Appellant Brief, permit appeal, case 14-148, 4121 20th St

Alteration Permit 2014/08/11/3496 for 4121 20th St owned by 20th Street Trust represented by Sarah Garlick.

Project: 4119 20TH STREET
SAN FRANCISCO CA

ATTACHMENT A

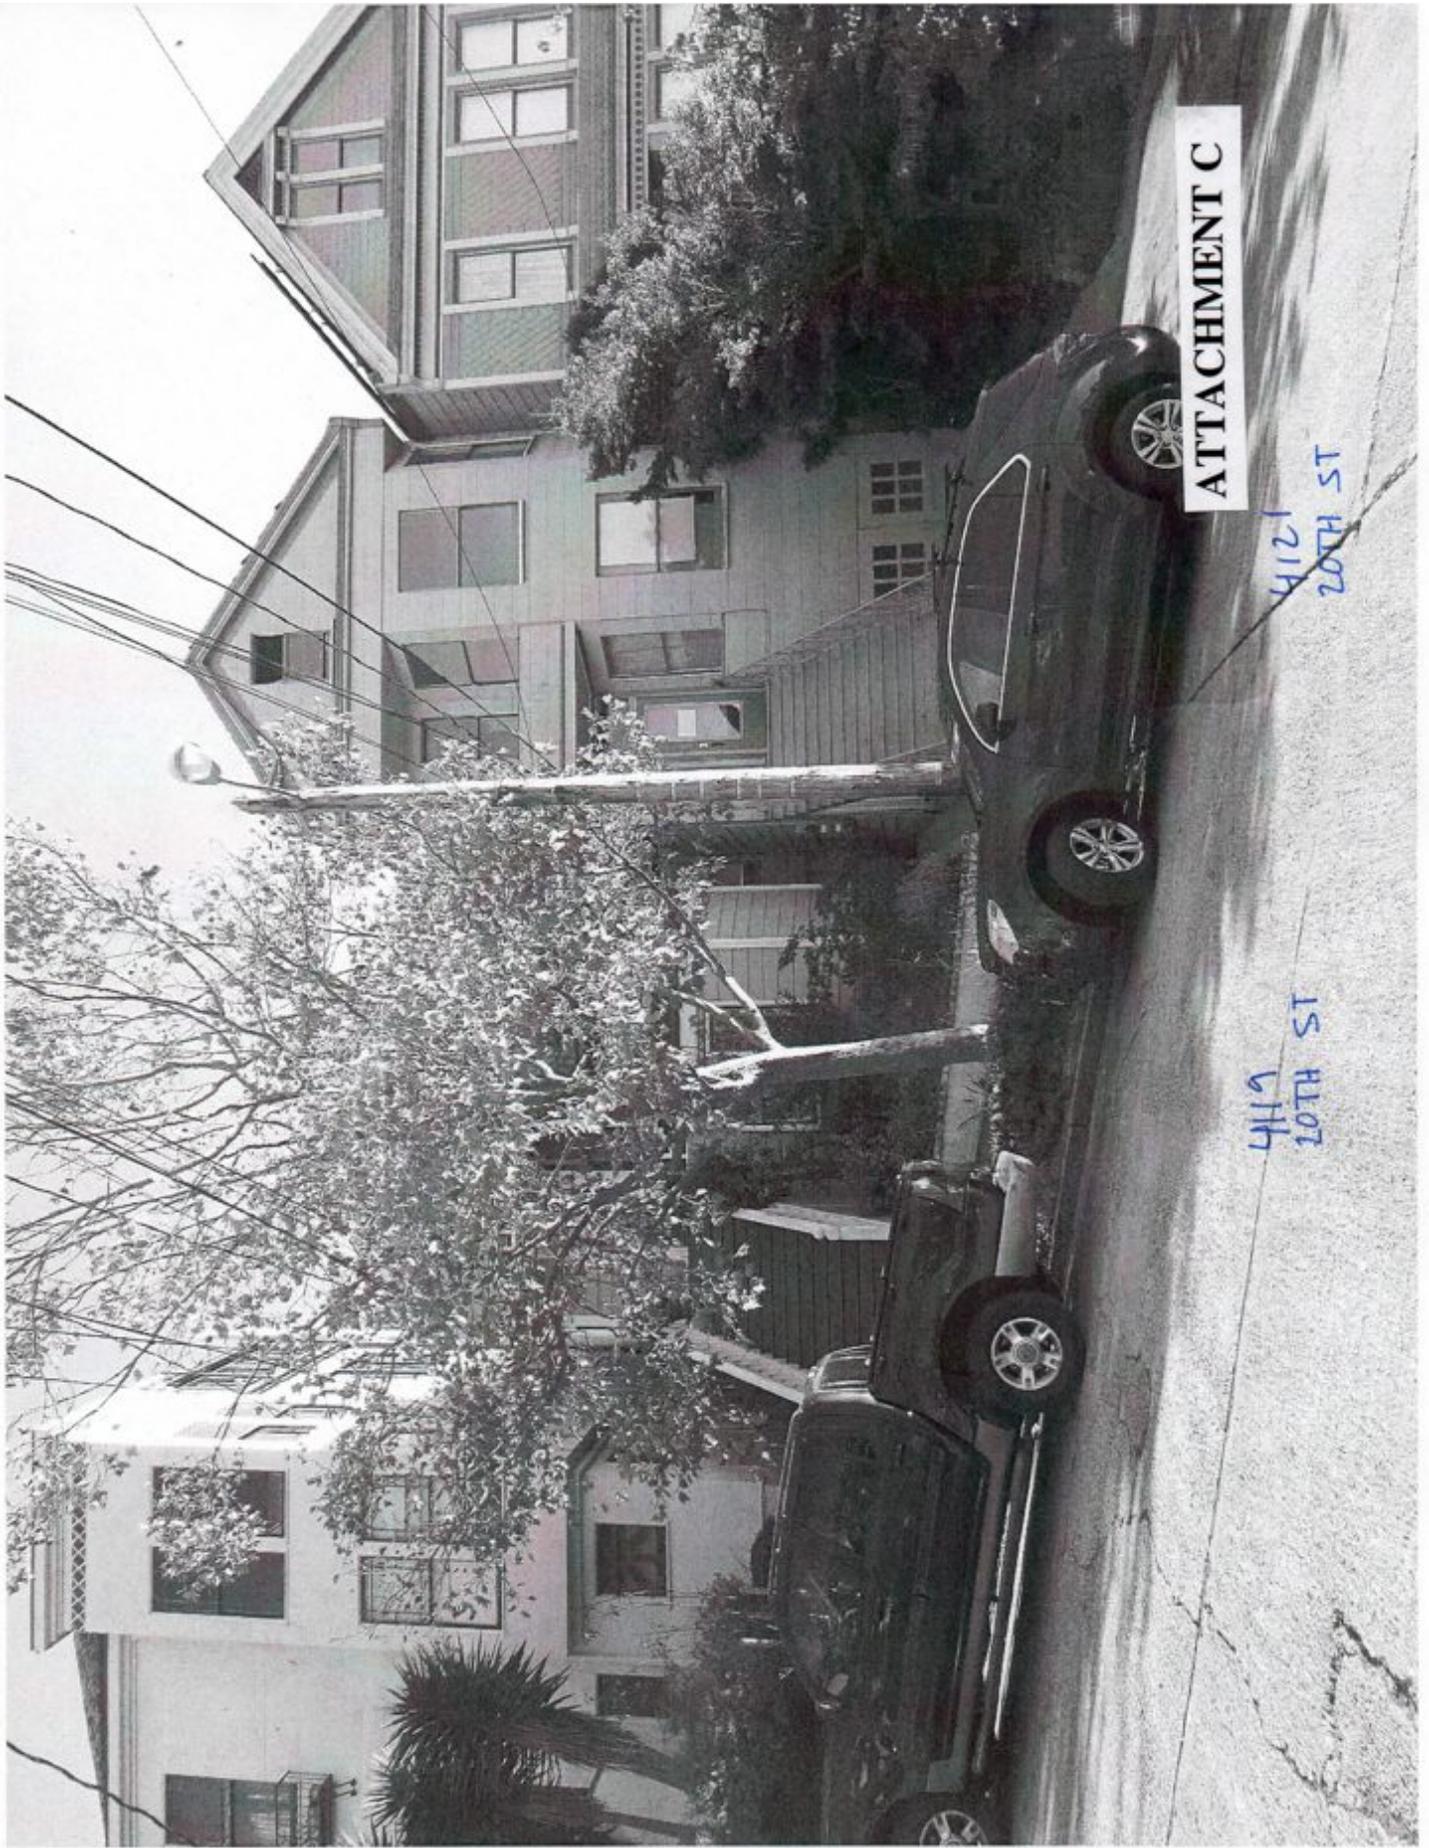
- Detail 1/S1.2 shows 6" between the bottom of the 4121 20th Street foundation and the finished grade of the 4121 20th Street basement. The photo you provided indicates that at the rear of 4121 20th Street, as well as at portions of the east perimeter wall at 4121 20th Street, the actual dimension between the bottom of the 4121 20th Street foundation and the finished grade of the 4121 20th Street basement is over 3 feet.

- Detail 1/S1.2 shows the bottom of the 4119 20th Street foundation 6" above the finished grade of the 4121 20th Street basement. The site conditions indicate that the bottom of the 4119 20th Street foundation is well over 3 feet above the finished grade of the 4121 20th Street basement.
